# **Volume determination of the strategic reserve for winter 2020-21**

**Answer to the public  
consultation on methodology,  
hypotheses and data sources**

Figure 4-1

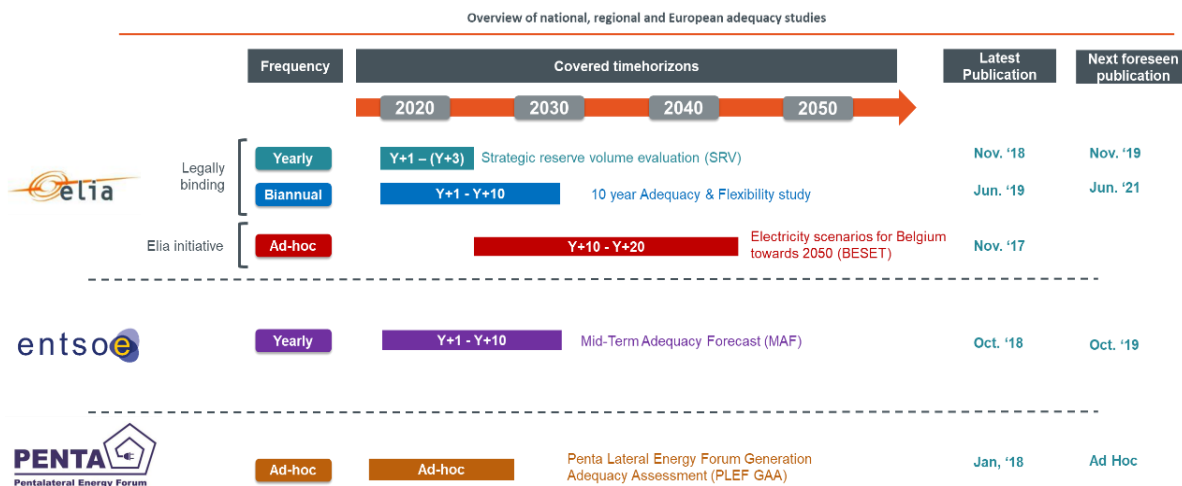
7. *[FEBELIEC] We would like to get some clarity on the relation between this exercise on the dimensioning of strategic reserve, the Adequacy and Flexibility study that Elia has to conclude by the 30<sup>th</sup> of June 2019 and the future regional resource adequacy assessment that will have to be conducted in case Belgium would opt for the implementation of a capacity remuneration mechanism in Belgium. It is clear that all three studies will discuss system adequacy in Belgium, but with different scope and time horizons as well as governance. However, it is unclear to what extent the current study with respect to the strategic reserve 2020-2021 is modified compared to the study for the strategic reserve for winter 2019-2020 in light of the discussions of Elia with other stakeholders, both market and non-market, on the other study currently being developed and the new or improved insights resulting from these (e.g. on total demand growth or the volume of market response).<sup>4</sup>*

Elia strives towards maximum consistency between its different studies. The adequacy assessment methodology is in line with European studies. The reasons for discrepancies between subsequent studies are the following:

1. As shown in Figure 4-1, the time horizons of Elia's studies differ. Short term and mid-term studies may require different approaches. A good example is the flow based model framework. Here for short term studies, historical domains are used, while for mid-term studies, a flow based prediction framework is applied.
